**Collingwood Green Phase 3
Invitations for Bids (IFB17-B002)
Issued: September 6, 2017**

**ADDENDUM #2
Issued: September 21, 2017**

ADDENDUM '02'

Project Name Collingwood Green Phase 3
Toledo, Ohio

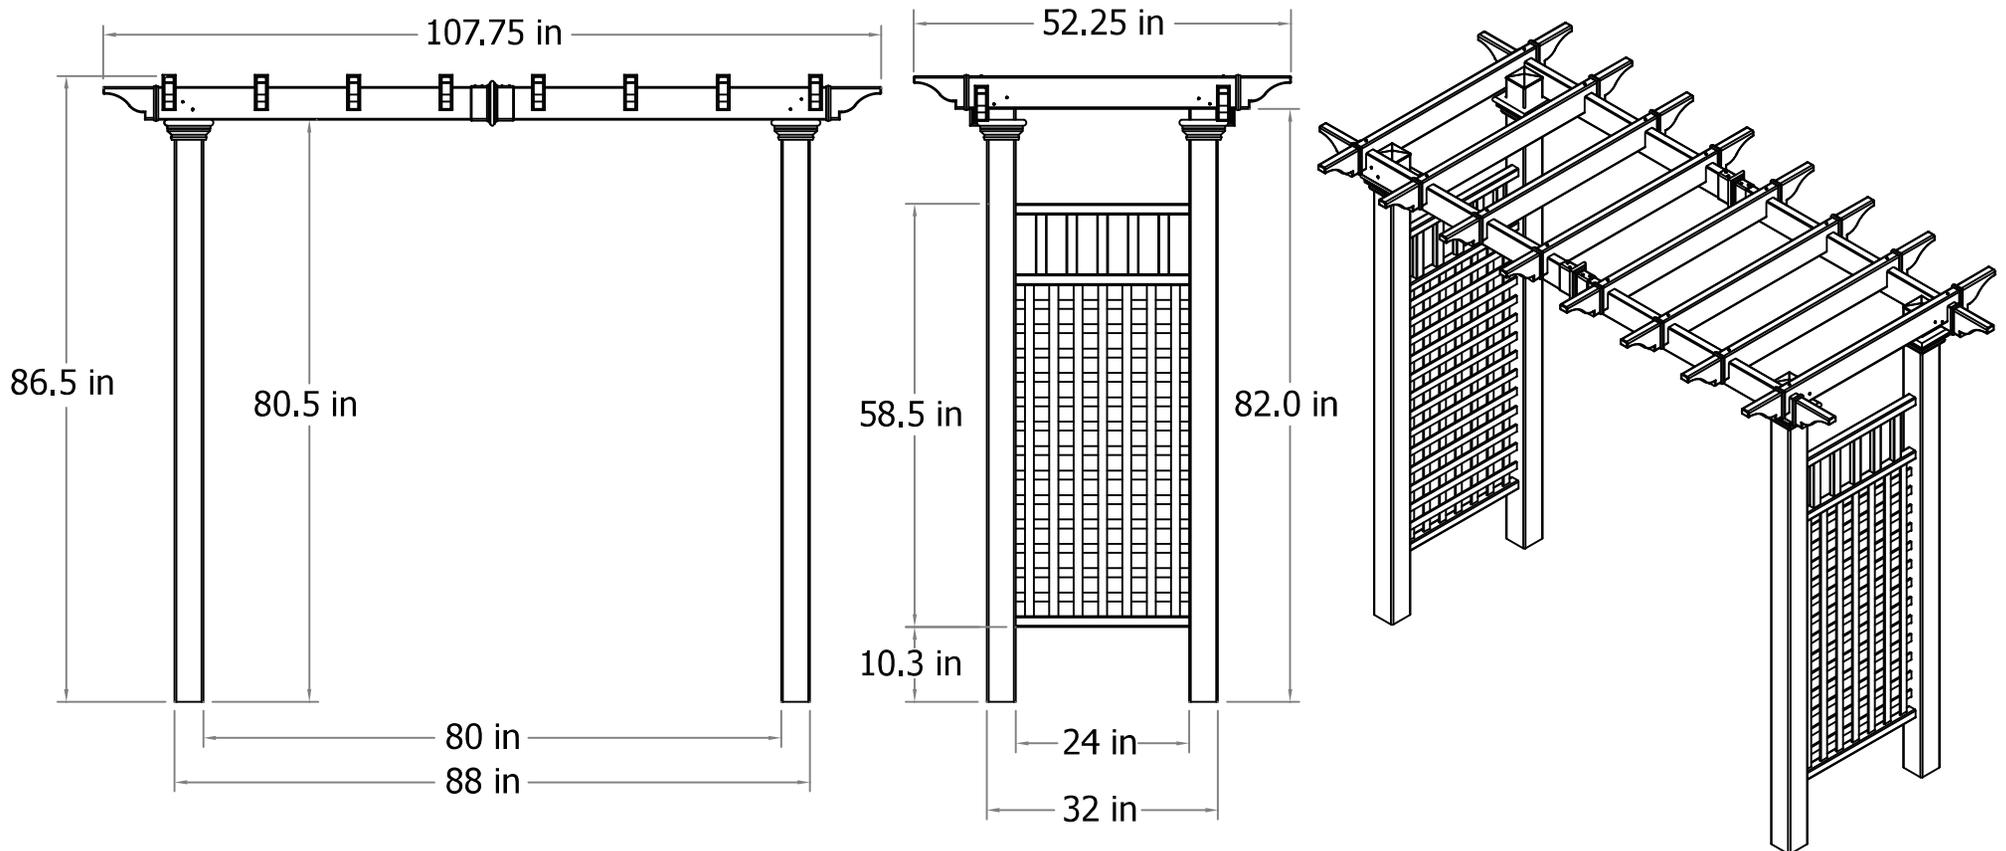
1. Sheet C401:
 - a. Detail H/C401: to be deleted
 - b. Detail P/C401: revise title to 'cleanout protection'
2. Site furnishings: Arbor identified on L1 sheets to be provided per attached cut sheet.

BUILDING A
FOUNDATION
PLAN

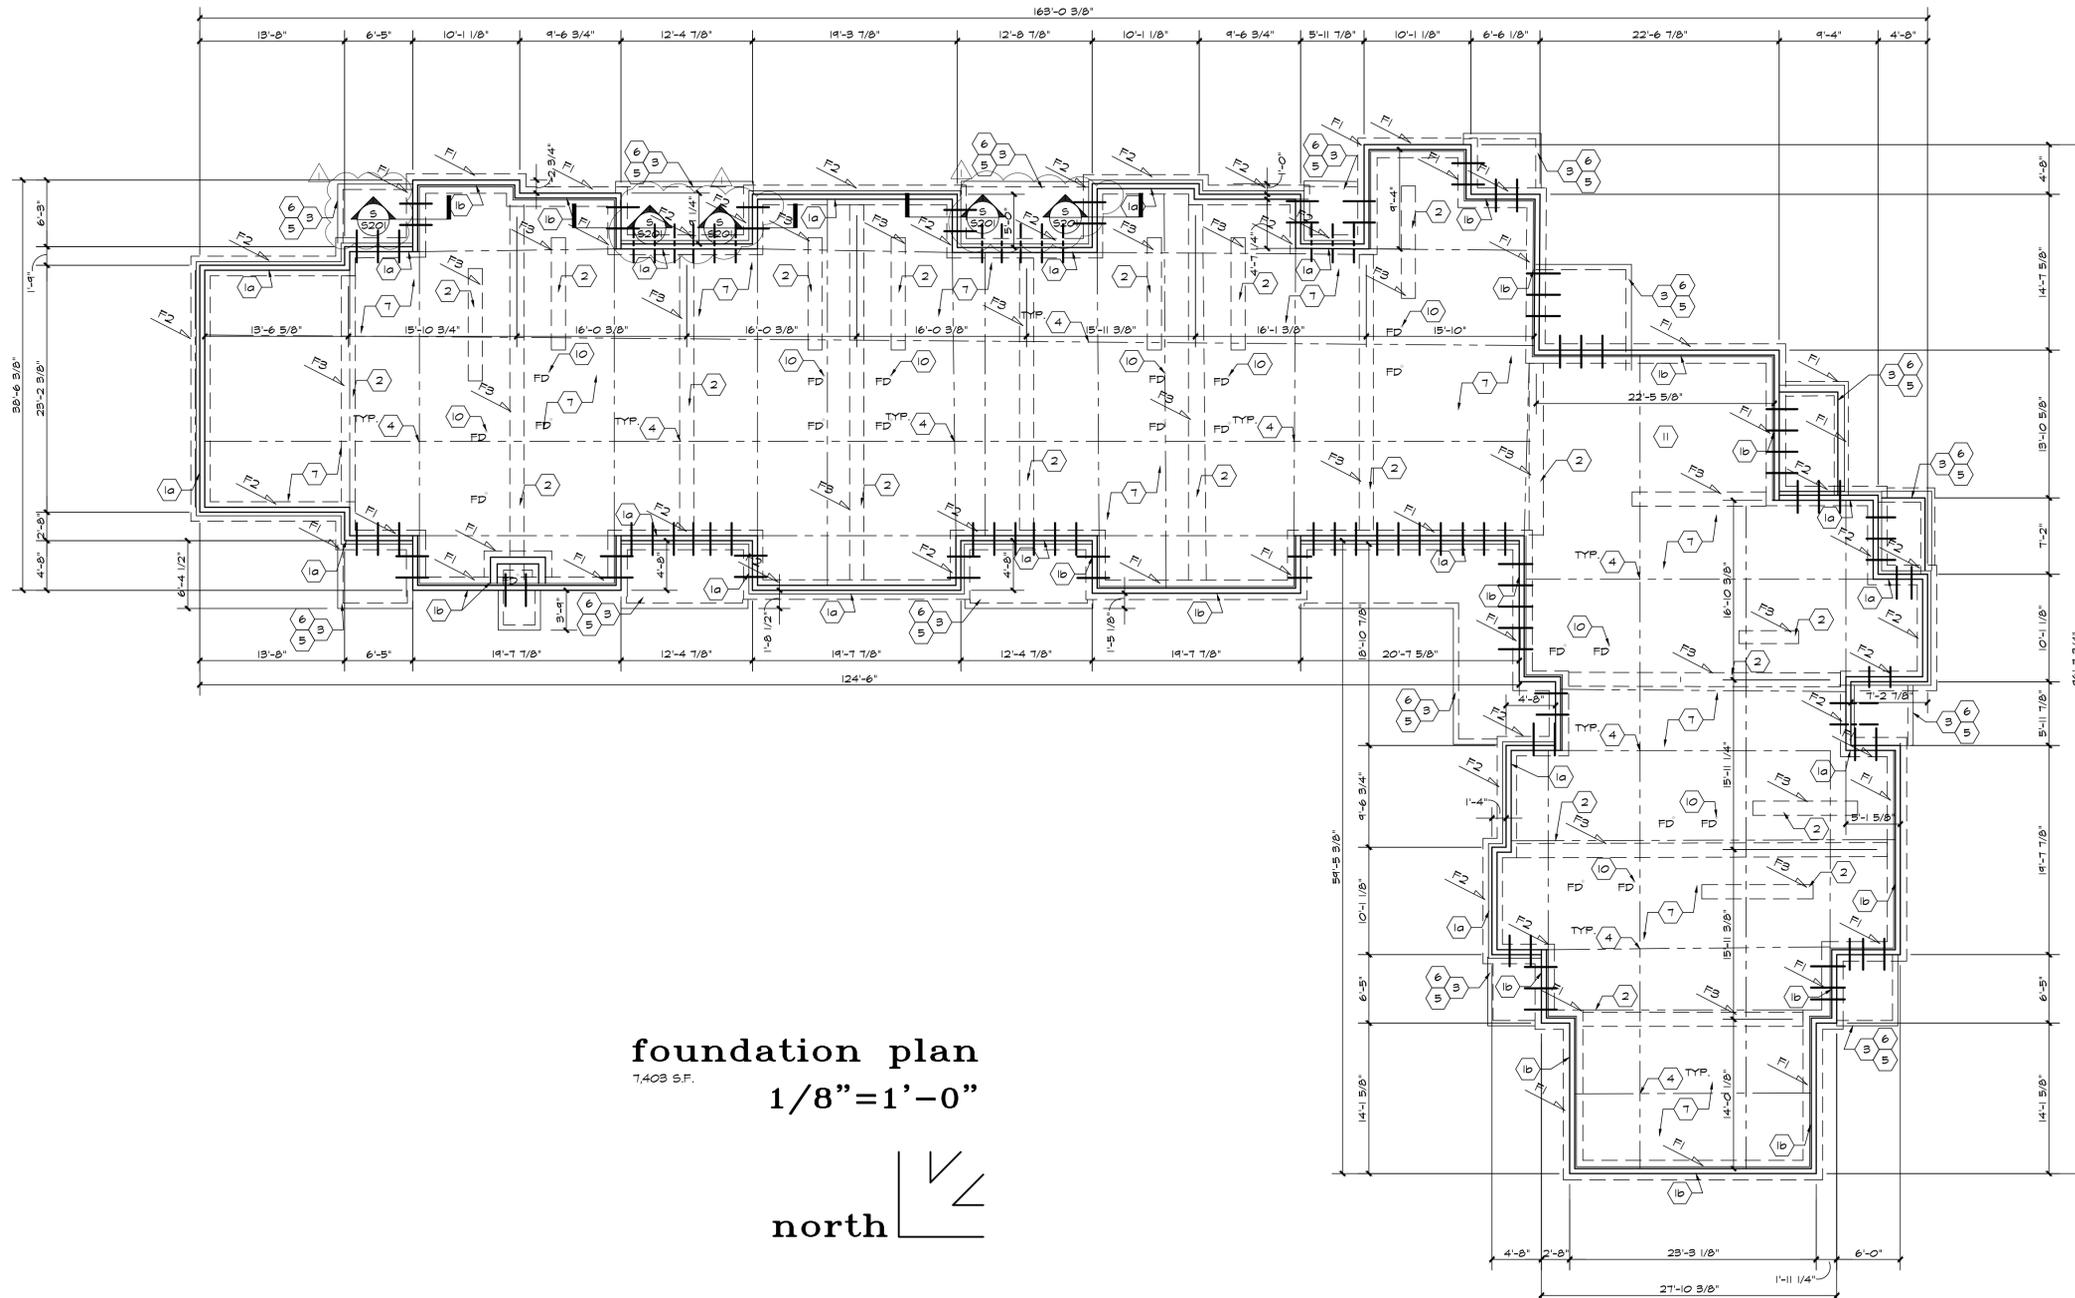
1. Sheets S101 Foundation Plans: have been revised for building dimensions – attached.
2. Sheets S101 Buildings A/B/C/D/F/H – Foundation Plans: section cuts have been identified at stoops with steps at entry door as indicated on Civil Grading Plans
3. Sheet S101H: Building step elevations have been revised.
4. Sheet S103 Buildings B/D/E/F/H – Roof Framing Plans: parking lot side roof elements have been removed from roof framing plans; see attached sheets.
5. Sheet S201 – Foundation Details:
 - a. S/S201 – Stepped Entry: Exposed block to be solid smooth face architectural block, color to be determined.
 - b. Details R and Q: Note that depth of foundation varies – coordinate with exterior elevations / Civil grading plan and foundation plans.
